UNITED STATES PATENT AND TRADEMARK OFFICE

APPLICATION NO.	FILING DATE	FIRST NAMED INVENTOR	ATTORNEY DOCKET NO.	CONFIRMATION NO.
09/704,808	11/02/2000	John F. Finley	1585.01	4313

Office Action Summary

DETAILED ACTION

FIG. 7

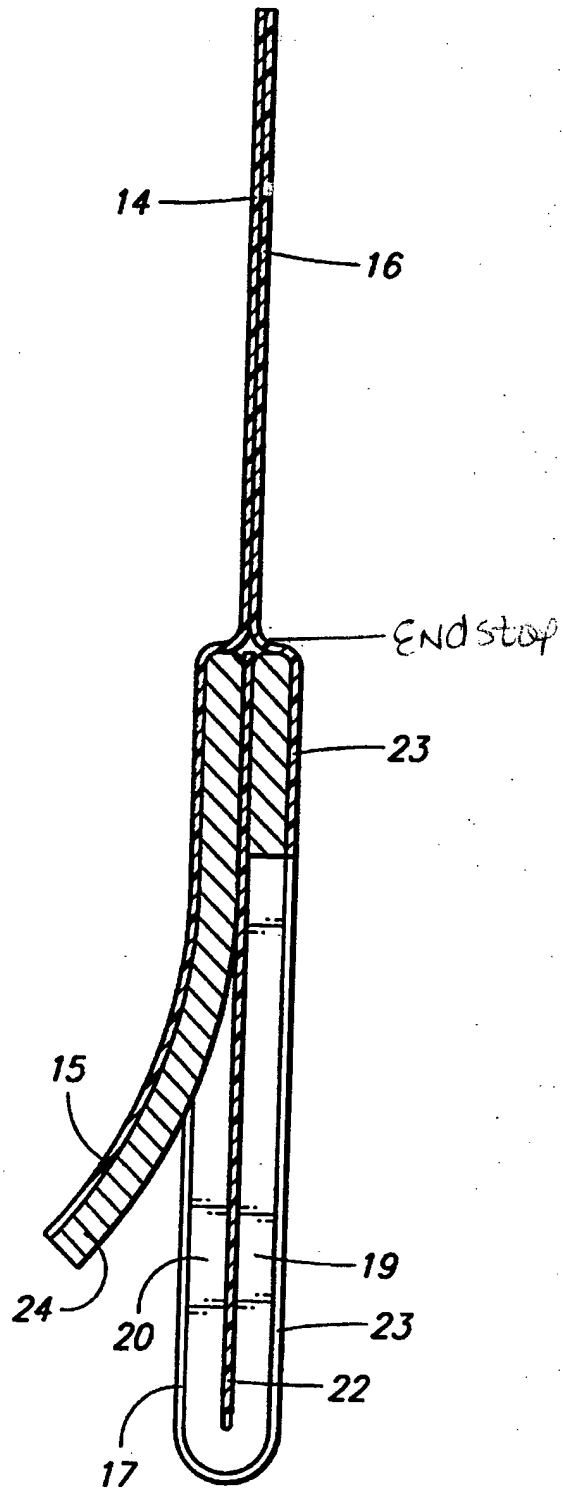
Regarding claims 2 and 12, Jacobsen further teaches an upper surface (fig.1), an essentially ventral aspect (14), an essentially dorsal aspect (17a, 17b), a dorsal perimeter (16, fig. 7), a buttress (25) and a flap essentially integrally extending dorsally from said buttress (15).

Regarding claims 4 and 14, as best as understood, Jacobsen further teaches an endstop (see marked copy figure 7).
